## SECTION 009113 – ADDENDUM 01

- A. Project Name: Sycamore Park River Overlook.
- B. Owner: Clermont County Park District.
- C. Architect: emersion DESIGN, LLC.
- D. Architect Project Number: 062305.
- E. Date of Addendum: August 09, 2024.

B. S-301 FRAMING DETAILS & SECTIONS

**NAILER SUPPORT OF BEAM OFF POST 7**  
3/4" = 1'-0" S-301

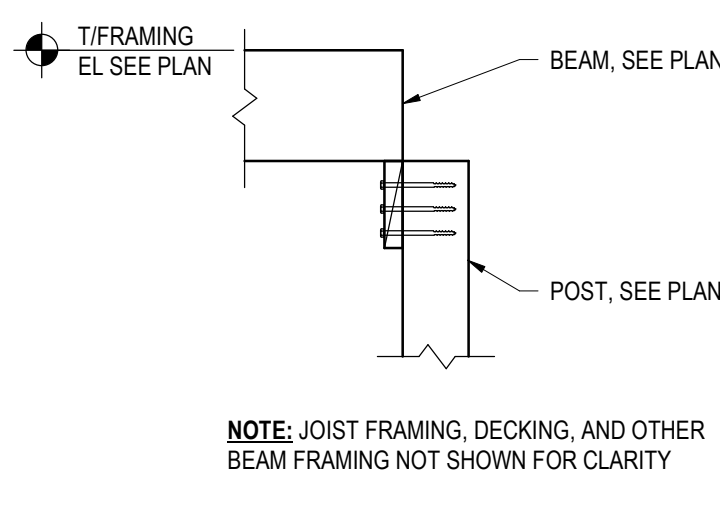
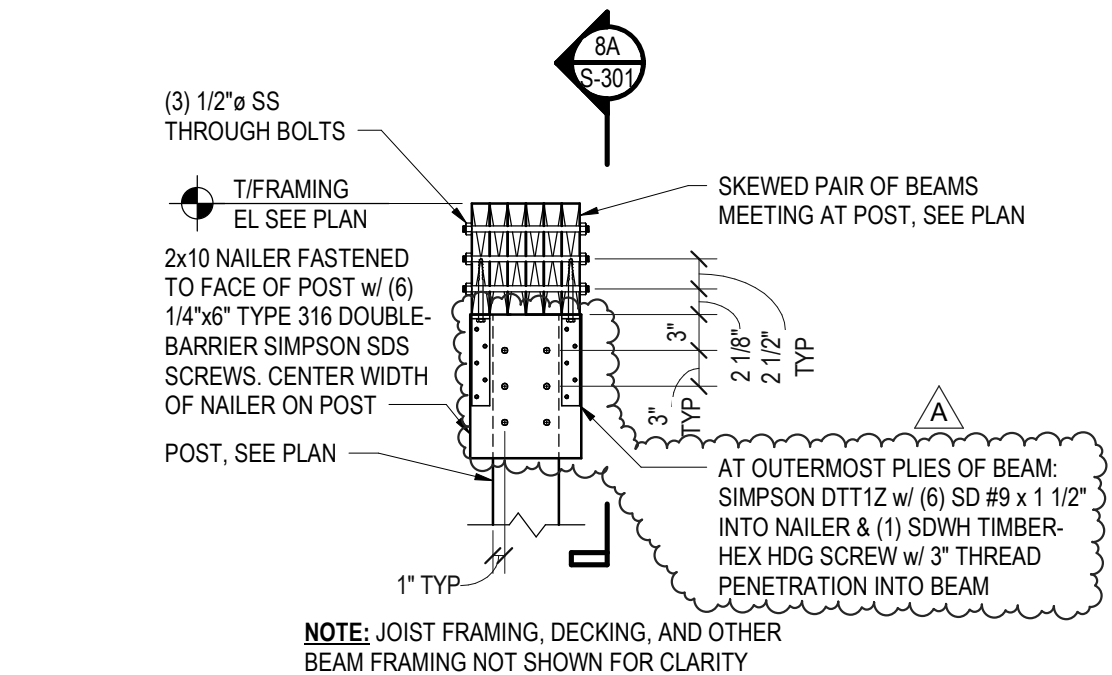
1. Revised detail 7/S-301.
2. Revised detail 8/S-301.
